Gateway Determination Report – PP-2024-1595

Parramatta Road Corridor Urban Transformation
Strategy (PRCUTS) – Stage 2

January 2025

Published by NSW Department of Planning, Housing and Infrastructure

Proposed Land Zoning Map

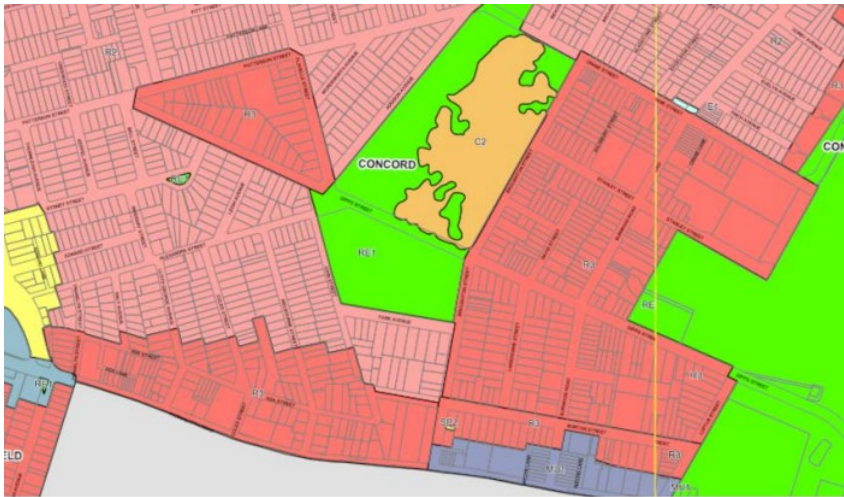
Some of the text and property boundaries in the draft Land Zoning Map and FSR Map are unclear. Sheet 003 of the draft Height of Buildings Map has not been provided.

- So that the text and property boundaries on the draft Land Zoning Map and FSR Map are legible.
- To include Sheet 003 of the draft Height of Buildings Map in draft LEP maps.
